HOMESTEAD NORTH AT STERLING RANCH FILING NO.3

STREET IMPROVEMENT PLAN

PCD-ENGINEERING REVIEW COMMENTS
IN BLUE BOXES WITH BLUE TEXT

**JESSE EVANS WEST CUL-DE-SAC PROFILE
STA 1+00.00 TO 3+89.59**

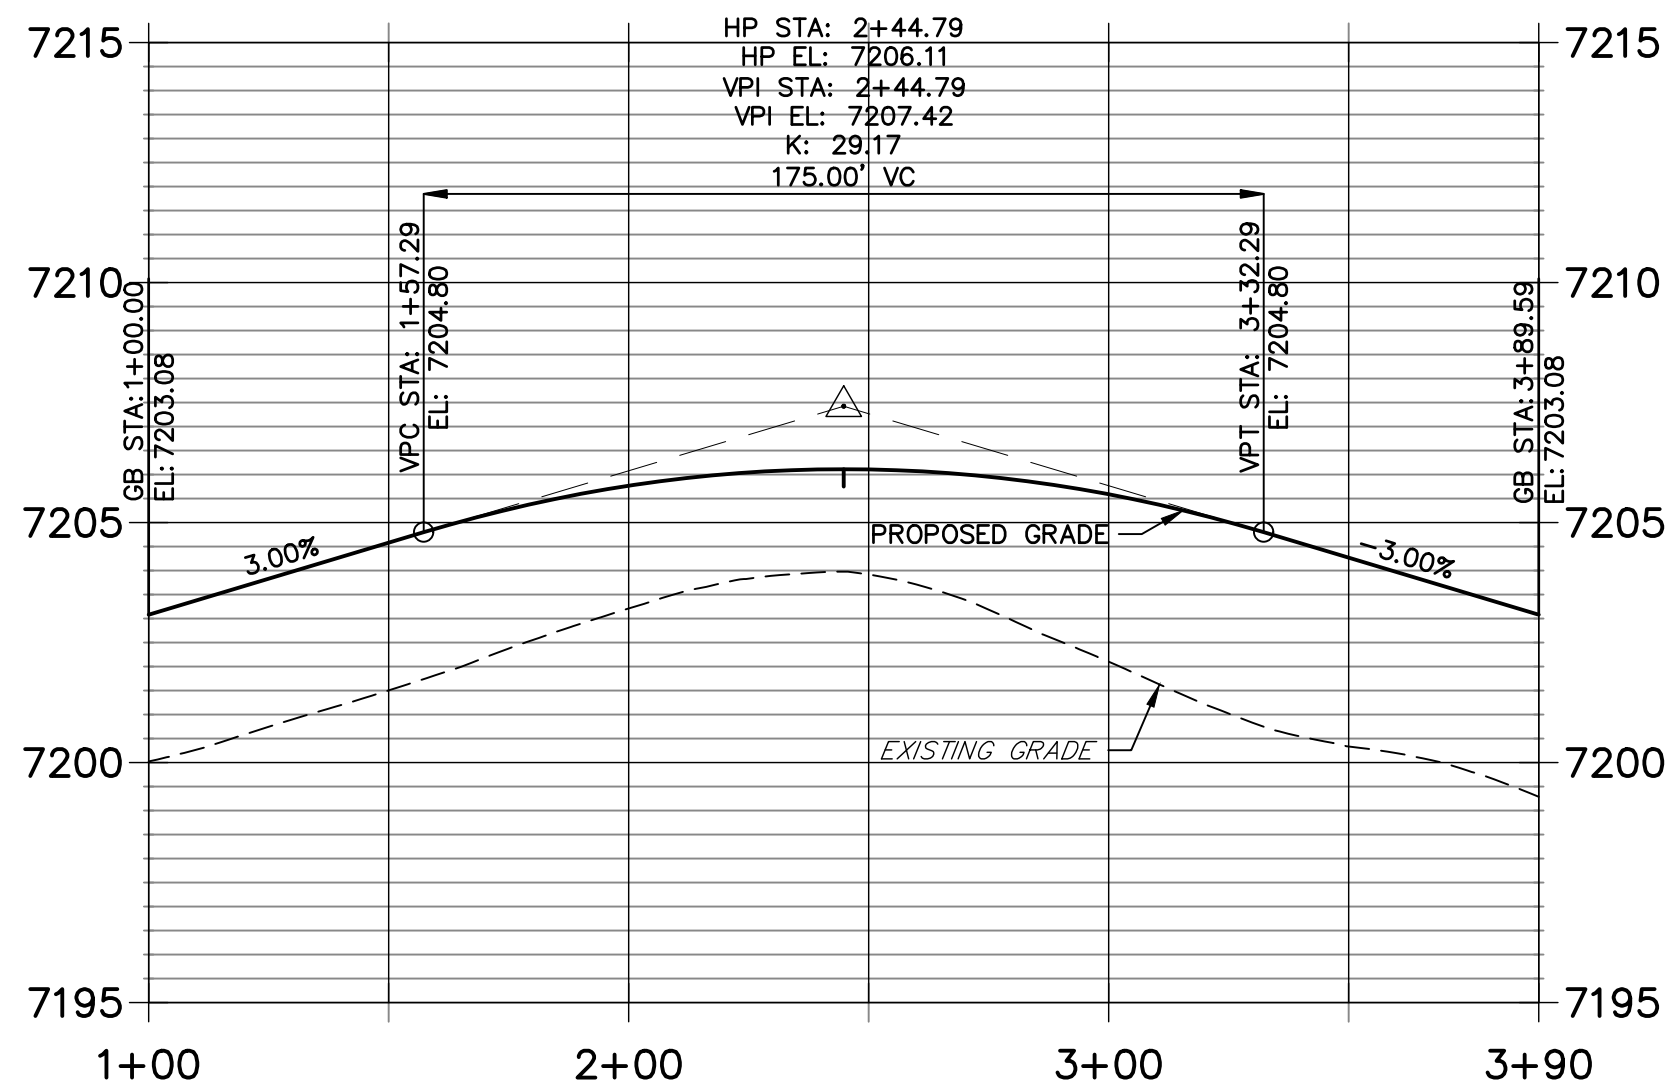
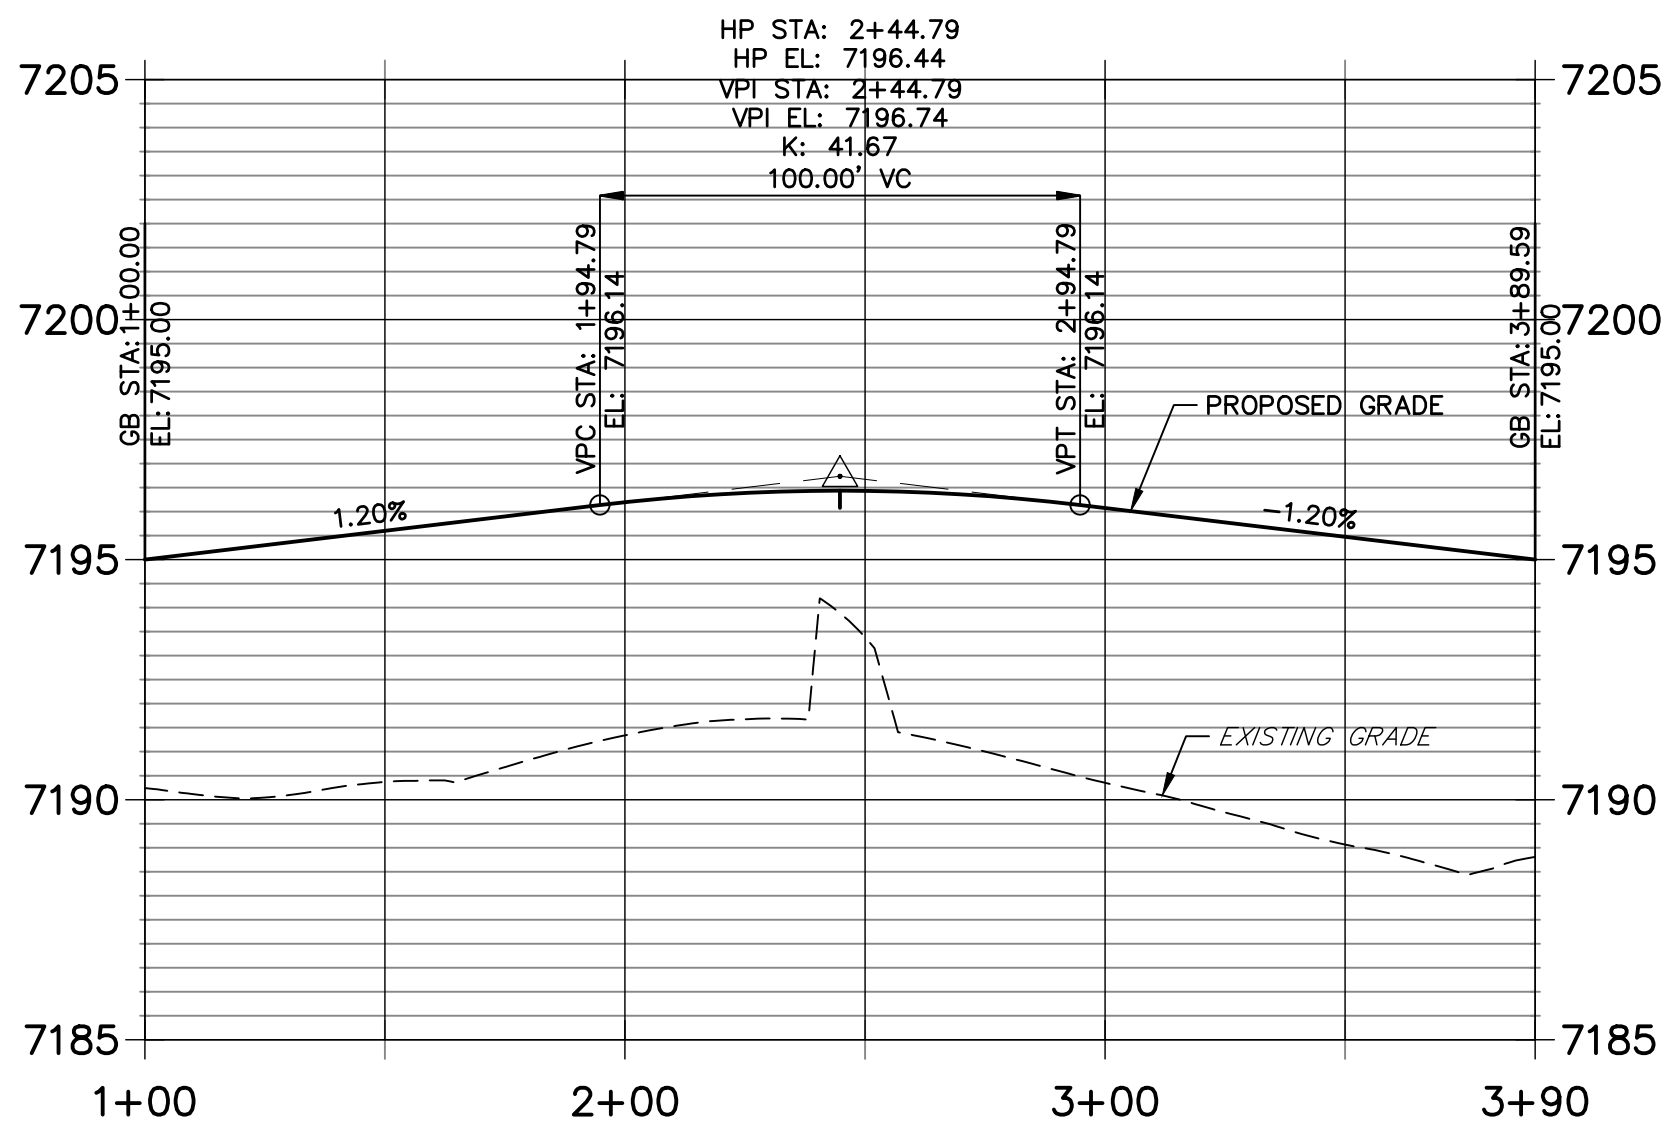
Show profile through end of cul-de-sacs (all profiles w/cul-de-sacs))

BILLY CLAIRBORNE DR- WILLIAM DOWNING DR. PROFILE STA 6+96.10 TO 12+00.00

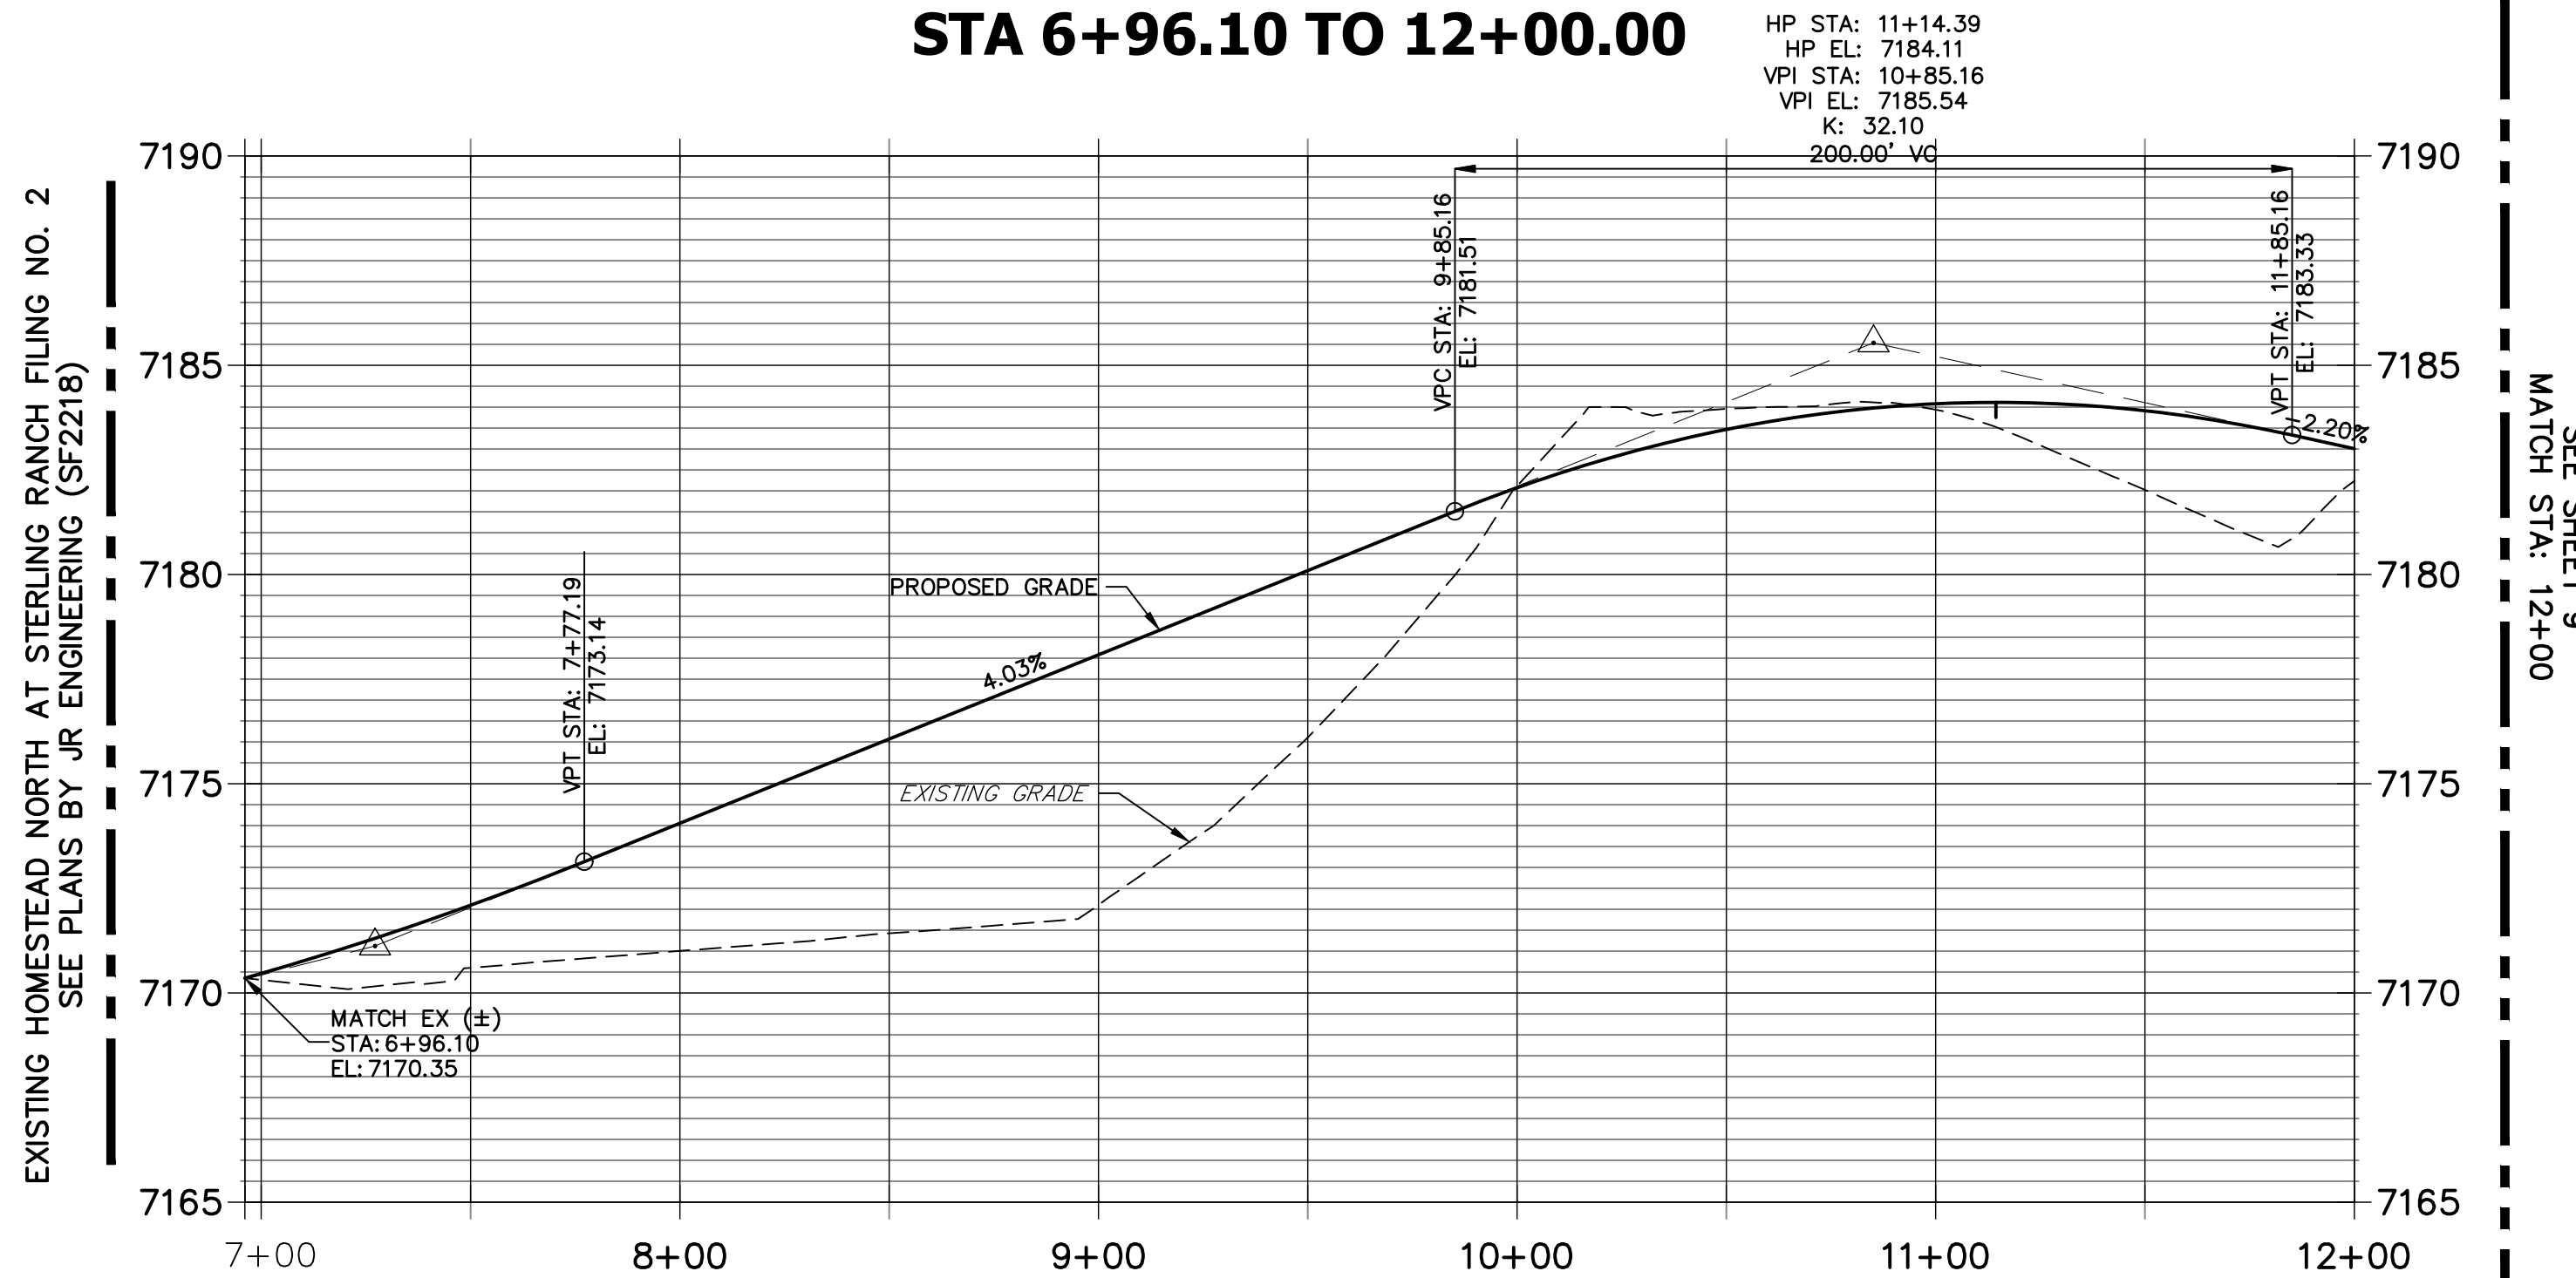
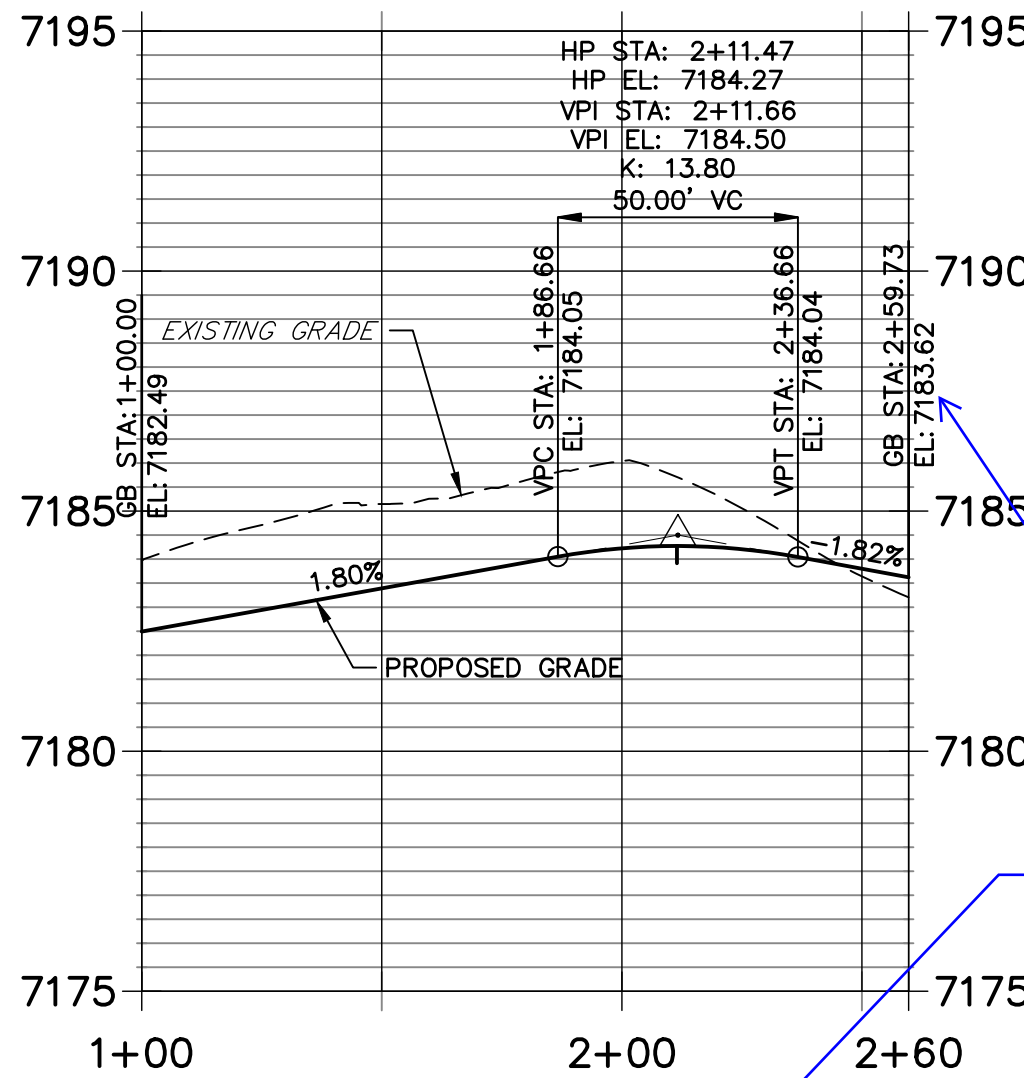
Doesn't match with elevation shown in point table

**DP01 PROFILE
STA 1+00.00 TO 10+06.62**

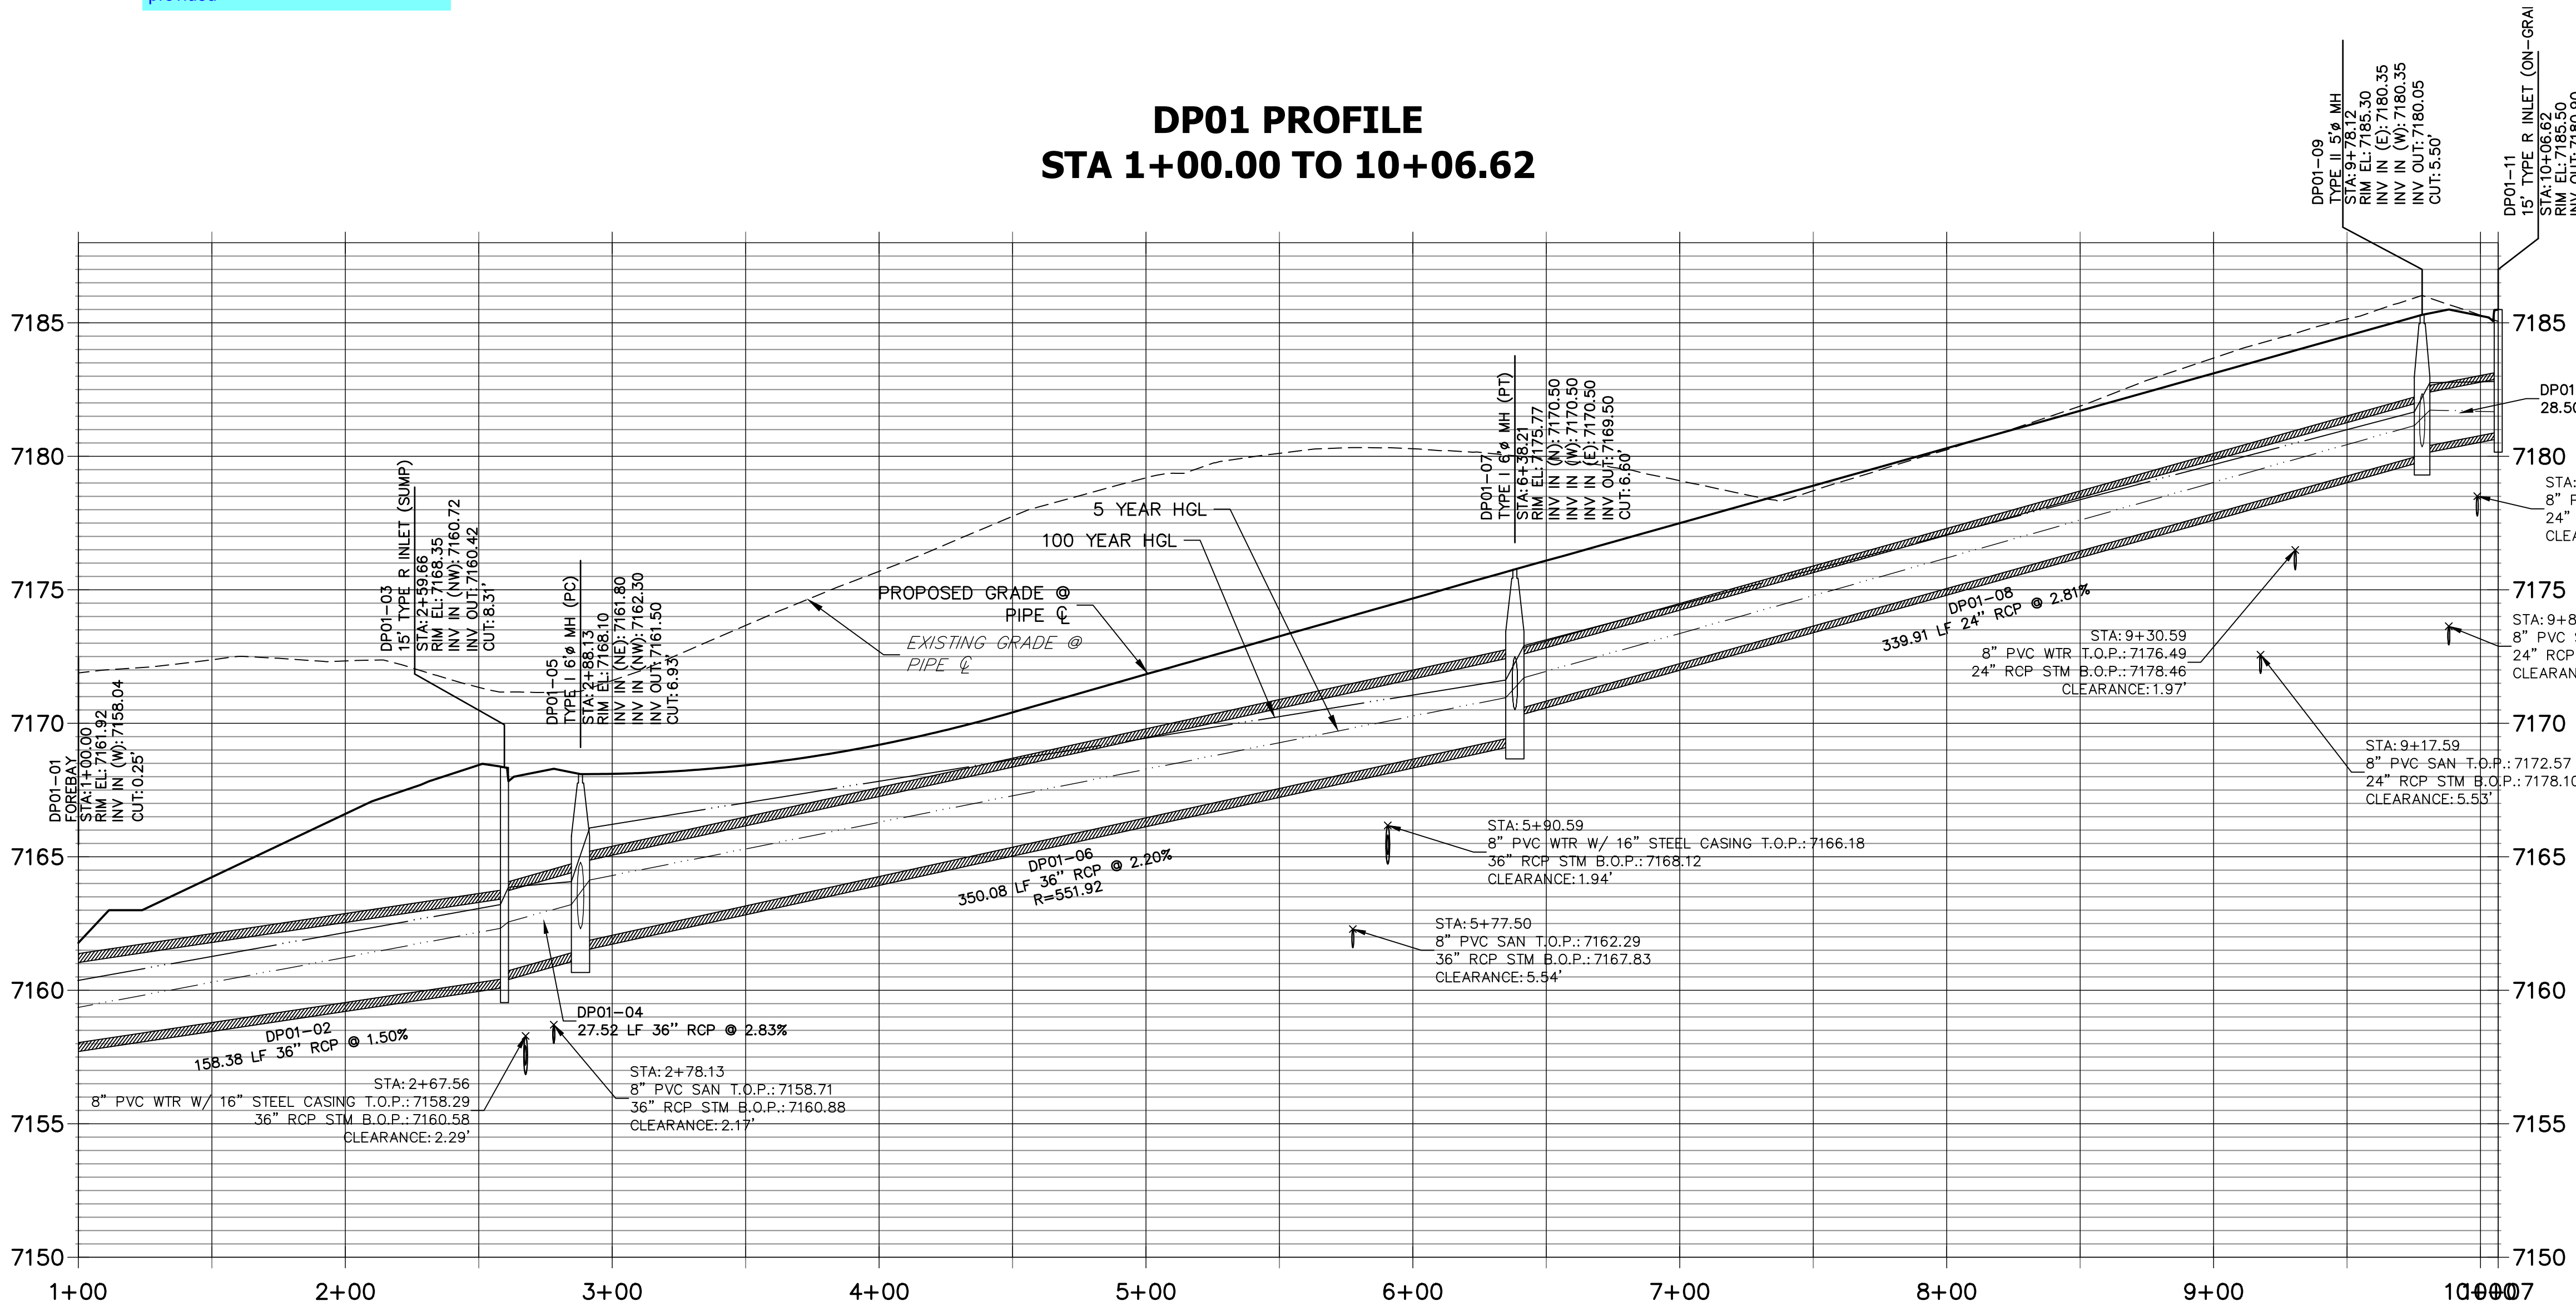
Storm Plan & Profiles will be reviewed with next submittal when Storm design (StormCAD) is provided
